Mad Moose Doors/Windows Design Review

3.) Change 3 of 4: East Facing Wall new panel door and windows installation: To enhance customer comfort and Mad Moose Café curb appeal. To be completed within 18 months of Design Review approval.

Mad Moose Café

New Wall / Sliding Panel Door Window Layout

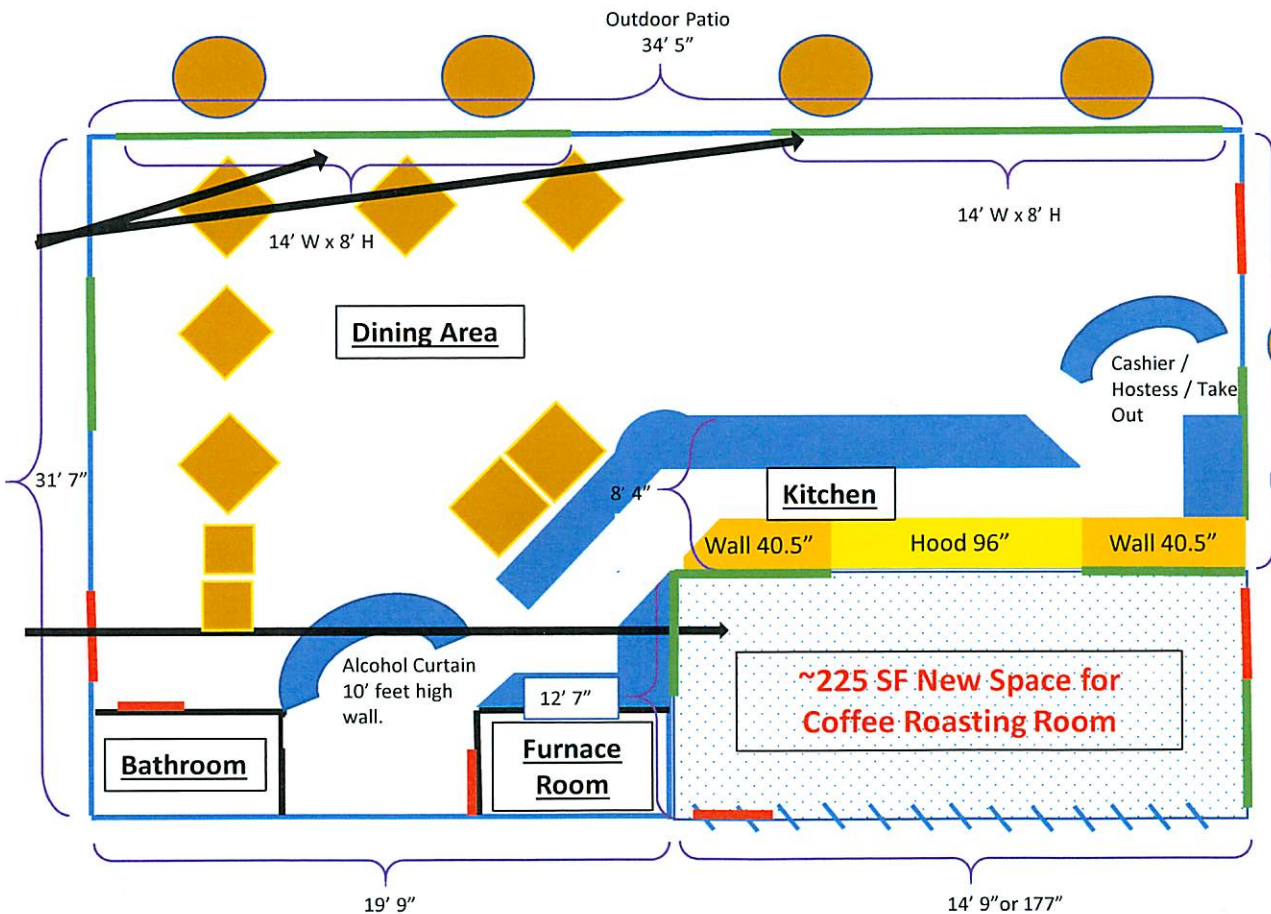
Specifications: 1. Install two sliding door systems 8'h x 14' w marked in green on east facing wall. 2. Add ~225 SF additional space indicated by "dotted" area in SW corner of café.

1. New Sliding Panel Window / Doors
(Location depicted by two solid green lines on east facing wall.)

2. Additional Space
West of Hood "dotted" ~225 SF. Includes new doors in red, new windows depicted in green. Windows added for customer viewing from within café. No walls removed, only 1 wall, 2 doors, 4 windows added to new room (New wall indicated by hash marks).

Mad Moose Cafe

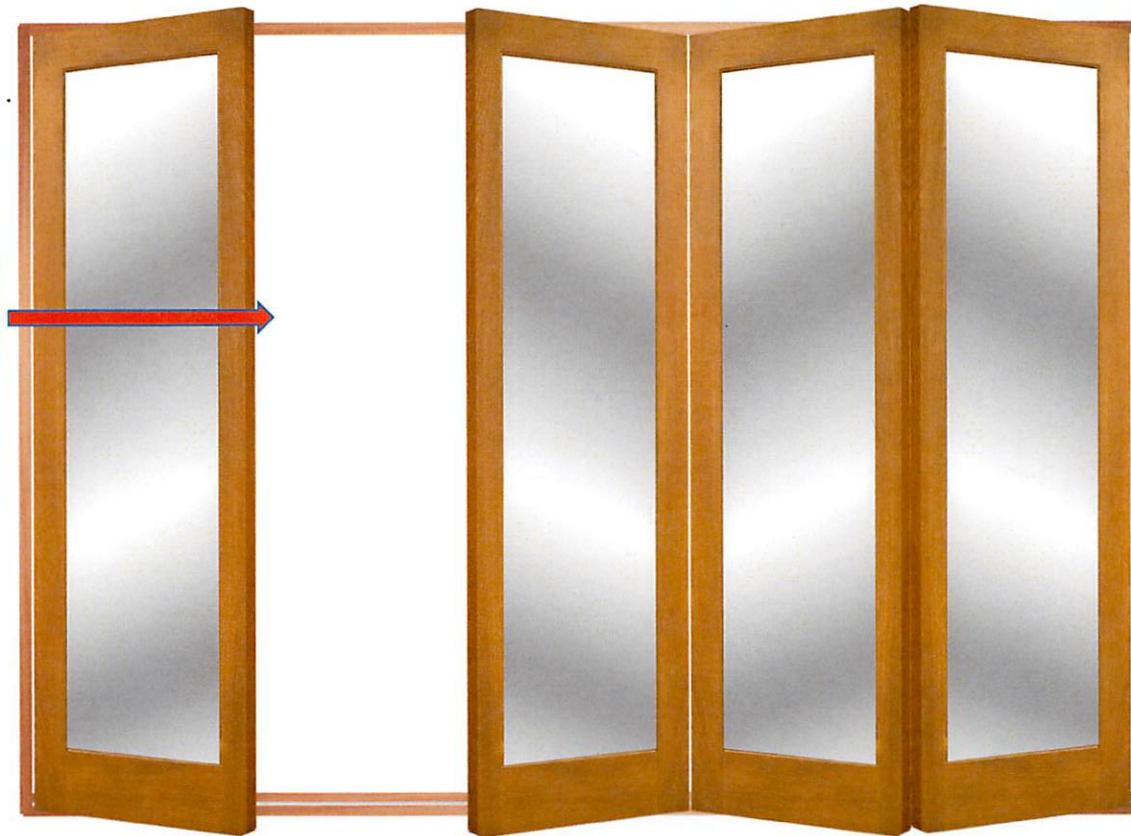
Location of proposed
12' window / door
systems (two each –
one on each side of
Chimney).
